# Service Bulletin

NO. 330

## Studebaker and Packard Clipper

Fig. 1

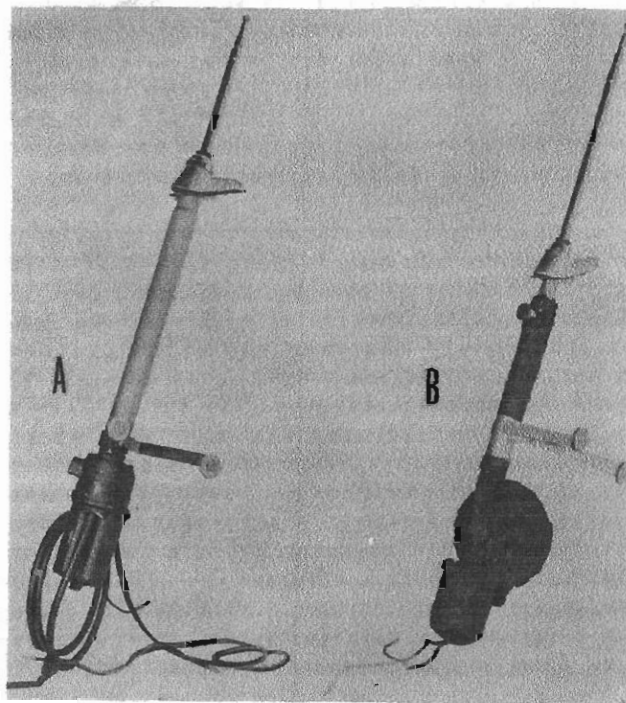
Two types of antennas were used on the 1957 Packard Clipper models; the Pioneer and Casco. They were, however, installed always as matched pairs of the same make in production.

The Pioneer unit, Part No. 469540, and the Casco unit, Part No. 439545, may be identified on the car through the chrome domed nut on top of the fender. The Pioneer has a domed nut

that measures approximately 1 1/16" (2,699 cm.) in diameter at its external base. The Casco nut measures approximately 1 5/16" (3,334 cm.) at its external base.

The two types are illustrated in Figure 1.

When a 57L model is equipped with dual antennas of the Casco type, the following components apply:

- 439545 Antenna Assembly
- 439806 Antenna Dome Nut
- 203905 Clip
- 415772 Grommet
- 439903 Switch
- 472052 Lead-in Cable
- 1543747 Cable Extension
- G128270 Screw
- 439807 Dome Nut Insulator
- 475134 Rear Antenna Cable to Operating Switch
